SKILLING, HELLE, CHRISTIANSEN, ROBERTSON — Structural & Civil Engineers

PROJECT: THE WORLD TRADE CENTER | TITLE: REPAIR AT EL. 310' | DATE: 5-26-72

12-JK7-20.1

Detail A

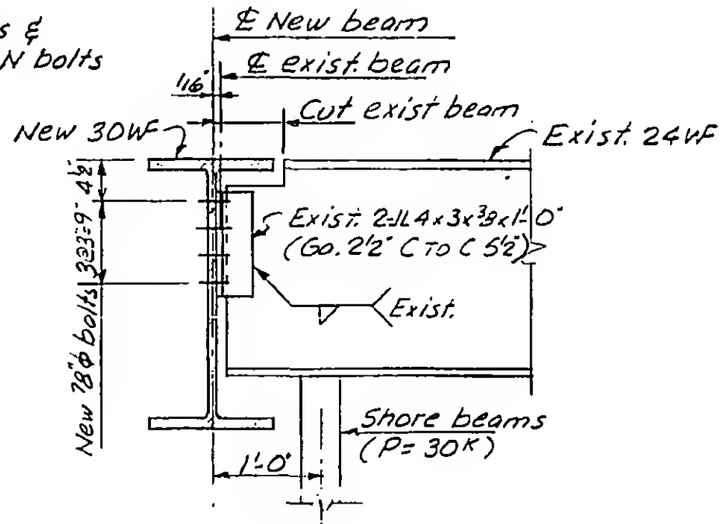
Note: Remove 7/8"ϕ exist. bolts & install new 7/8"ϕ A490-N bolts with new beam.
